# CLAS12 RICH ERR Recommendations

Gas system on level 4: compressors (Left) tank + panels (Right)

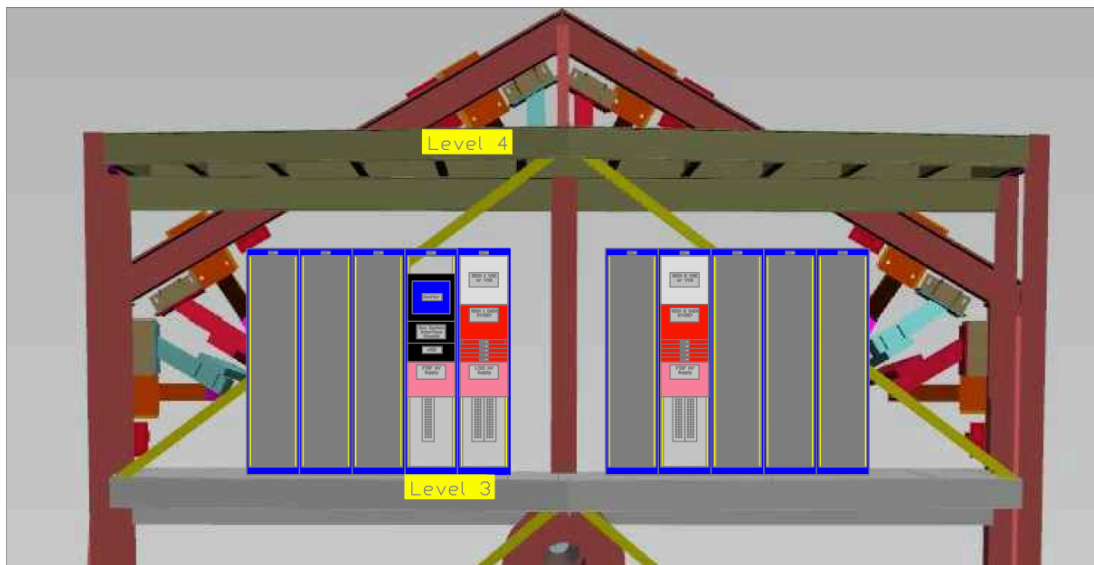
5. The space for compressors and cabling must be clearly identified and reserved for RICH use.

Power supply + DAQ on level 3:  
C3-5: CAEN SY4527, R649 distribution  
C3-6 (or C2-4) VSX crate with fiber distribution

Cable path and length approved by Eugene Pasyuk
